UNITED STATES PATENT AND TRADEMARK OFFICE

APPLICATION NO.	FILING DATE	FIRST NAMED INVENTOR	ATTORNEY DOCKET NO.	CONFIRMATION NO.
10/698,682	10/31/2003	Greg Franke	200315010-1	3560
22879	7590	09/29/2005	EXAMINER	
HEWLETT PACKARD COMPANY P O BOX 272400, 3404 E. HARMONY ROAD INTELLECTUAL PROPERTY ADMINISTRATION FORT COLLINS, CO 80527-2400			BROUSSARD, COREY M	
			ART UNIT	PAPER NUMBER
			2835

Office Action Summary

DETAILED ACTION

Fig. 1

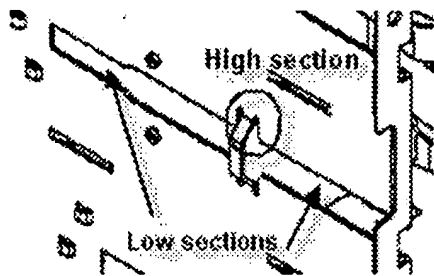
11. With respect to claim 19, Chen teaches wherein the first slot is nonlinear and comprises a first and second low sections disposed at the opening and the termination, respectively (see present Office Action Fig. 1 below, taken from Fig. 4 of Chen),

and a high section disposed between the first and second low sections (see present Office Action Fig.1 above), the high section clearing the profile of the media drive when the media drive is fully inserted in the cage such that air may flow through the high section into or out of the cage, unimpeded by the media drive.
